Number: SB 2X-71-17

SNS SUBJECT: 71-60 AIR INTAKES - Disbonding Of Induction System Air Box Seal(s)

This Service Bulletin provides instructions for the replacement of the air box seals.

Figure 1
Air Box Seal Installation

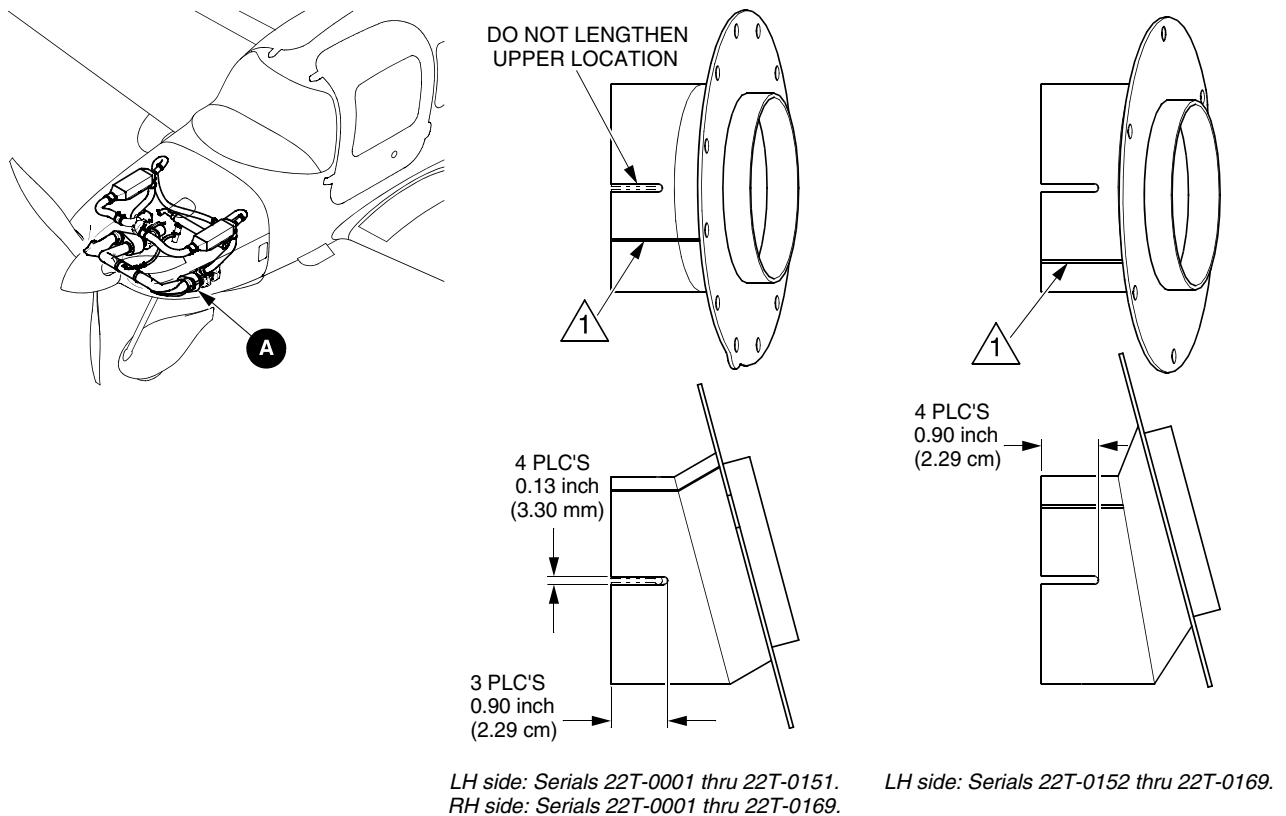
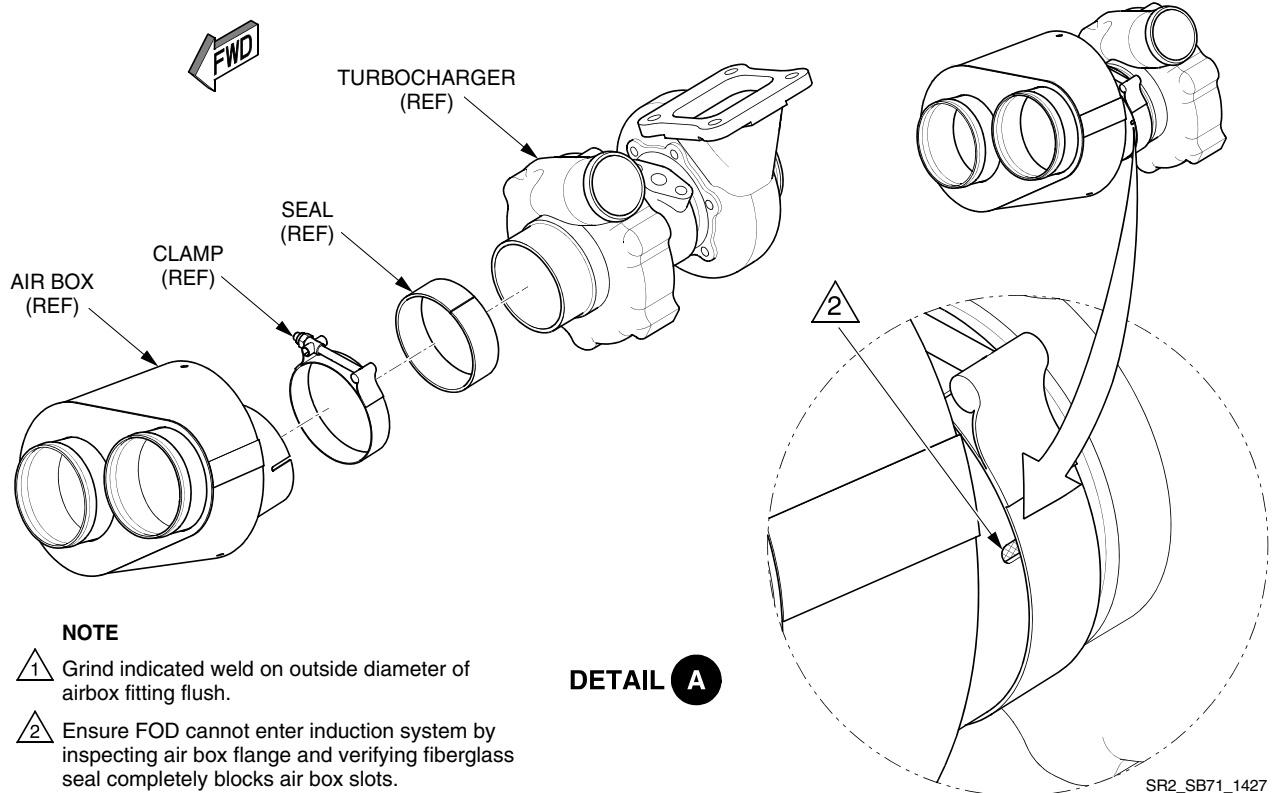
- B. Remove engine cowling. (Refer to AMM 71-10)
- C. Remove clamp securing air box to turbocharger.
- D. Disconnect air box from turbocharger.
- E. Remove and discard black rubber seal from air box.
- F. Remove residual adhesive from air box.
- G. Using Grinding Wheel, grind weld on outside diameter of airbox fitting flush to surrounding surface.
(See Figure 1)

Using Cut-Off Tool, extend three of the four air box flange slots to 0.90 inch (2.29 cm) with full radius on the end. Do not extend the top slot nearest to the weld.

Using Cut-Off Tool, increase width of all four air box flange slots to 0.13 inch (3.30 mm).

Using Cut-Off Tool, extend all four air box flange slots to 0.90 inch (2.29 cm) with full radius on the end.

Using Cut-Off Tool, increase width of all four air box flange slots to 0.13 inch (3.30 mm).

Using Cut-Off Tool, extend three of the four air box flange slots to 0.90 inch (2.29 cm) with full radius on the end. Do not extend the top slot nearest to the weld.

- T. Install air box over turbocharger induction mounting flange. Torque clamp to 90-100 in-lb (10-11 Nm).
- U. Ensure FOD cannot enter induction system by inspecting air box flange and verifying fiberglass seal completely blocks air box slots. (See Figure 1)
- V. Install clamp securing air box to turbocharger.
- W. Repeat procedure on opposite turbocharger.
- X. Install engine cowling. (Refer to AMM 71-10)
- Y. Complete airplane records by noting compliance with SB 2X-71-17 in Aircraft Logbook.
